REMARKS

This Application has been carefully reviewed in light of the Office Action mailed October 23, 2003. Applicants amend Claims 1 and 8 to correct typographical errors. Applicants also amend Claims 6, 12, 15, and 18 to clarify the original intent of these claims. Applicants respectfully request reconsideration and favorable action in this case.

FIG. 3

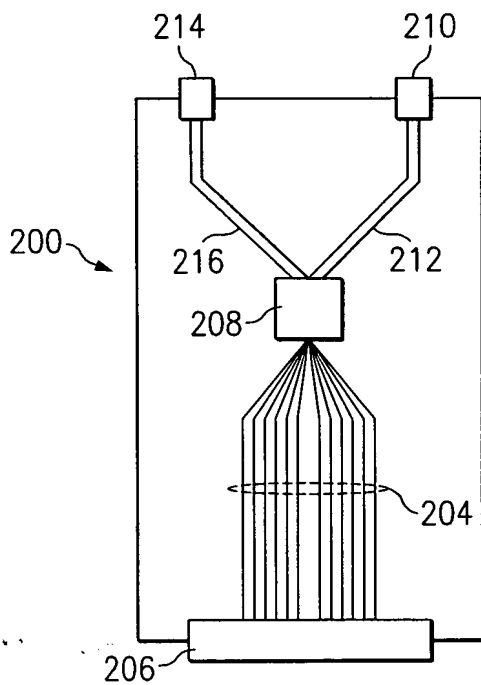
The Examiner objected to the drawings under 37 C.F.R. § 1.83(a) as not showing every feature of the invention specified in Claim 8. Applicants amend Figure 3 to include previously omitted diodes 73 and resistors 75. Applicants submit that these changes are fully supported by the specification as originally filed and therefore do not constitute new matter. For these reasons and other reasons clearly apparent, Applicants respectfully request reconsideration and withdrawal of the objection to the drawings.

Elements
 73 and 75
 added
